Service Kit

759-04277

Subject: Service Replacement for:
617-04036, 617-04037 and 718-04269

REFERENCE: S/A CC-681

FIGURE 1

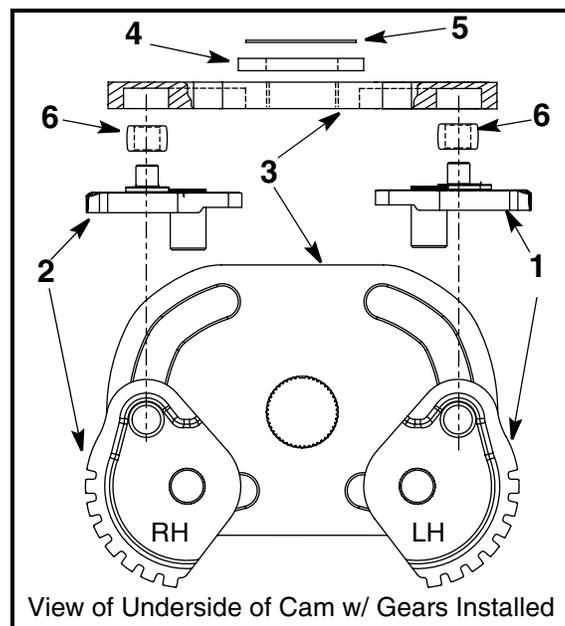
PURPOSE: This service kit provides the latest production RH and LH bevel gear assemblies, steering cam (Hydro) and necessary hardware when replacing either the 617-04036 LH Bevel Gear or 617-04037 RH Bevel Gear or the 718-04269 steering cam, which are no-longer-available, in the 618-04634 or 618-04430 steering gearboxes. If only one of the bevel gears or the steering cam are damaged, both new bevel gears, the new steering cam and hardware supplied must be replaced as a complete set. This kit is only applicable to iSeries riders with hydrostatic transmissions.

ITEM NO.	PART NUMBER	QTY	DESCRIPTION
1	617-04047	1	GEAR ASM:BEVEL:STEERING:LH:27T
2	617-04048	1	GEAR ASM:BEVEL:STEERING:RH:27T
3	718-04644	1	CAM:STEERING:HYDRO
4	736-0274	1	WASHER:FLAT: 1.01 x 1.750 x .172
5	736-0615	1	WASHER:THRUST: .793 x 1.368 x .015
6	741-04204	2	BEARING:SLEEVE: .437 DIA. x .3425 LG.
7	*	1	THIS INSTRUCTION SHEET
